# UNITED STATES PATENT AND TRADEMARK OFFICE

10/536,865

<b>Office Action Summary</b>	<b>Application No.</b> 10/536,865	<b>Applicant(s)</b> SOMERVILLE, DECLAN	
	<b>Examiner</b> RYAN J. FRANKS	<b>Art Unit</b> 3633

## **DETAILED ACTION**

Fig. 8 from Bullard

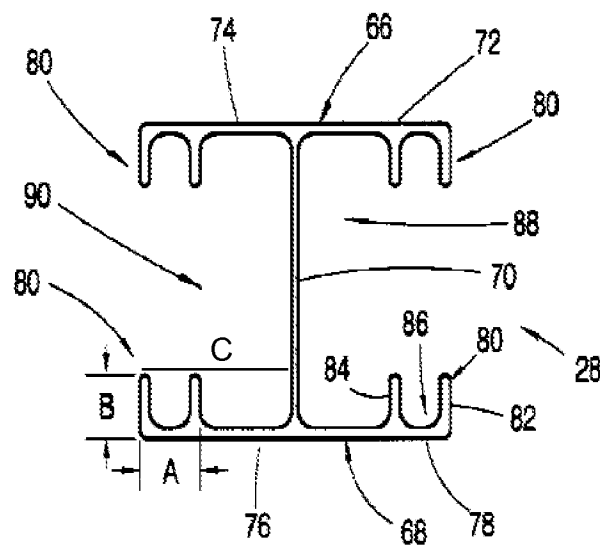
Regarding claim 1, Bullard discloses an “extrusion (column 4, line 15; Fig. 8 in general) [having] a central wall portion (70) and a surrounding perimeter portion (72/74/76/78),

whereby the central wall divides the extrusion into opposing chambers (88/90), said perimeter portion having a respective opening therein into each of said chambers (lack of material at left of 90 and at right of 88) and each chamber being able to have a perimeter portion of a further extrusion locked thereinto to form an interlocked unit.”

Two extrusions are able to interlock by inserting an edge of one extrusion into chamber of another. For example, an extrusion having the same external dimensions as the internal dimension of the chamber could be inserted into the chamber.

Regarding claim 2, Bullard discloses that the perimeter has opposing pairs of sides but lacks that one pair of sides is longer than the other pair of sides. It would have been obvious to one of ordinary skill in the art at the time the invention was made to change the shape of the extrusion, for example, by making the right and left sides of Fig. 8 longer than the top and bottom sides of Fig. 8 thus having the longer sides contain the

openings to the chambers 90 and 88, since a change of shape has been held to be within the skills to one of ordinary skill in the art as a matter of obvious design choice. (See MPEP 2144.05).

Regarding claim 3, Bullard discloses that "the central wall divides the extrusion into two chambers of equal dimension." At Fig. 8, central wall 70 forms chambers 88 and 90 which are seen to be of equal size.

Regarding claim 4, Bullard discloses that "the closed side wall has external dimension that corresponds to the length of the central wall". The shorter sides as indicated with claim 2 at 66 and 68 are seen to be the same size as central wall 70 in Fig. 8.
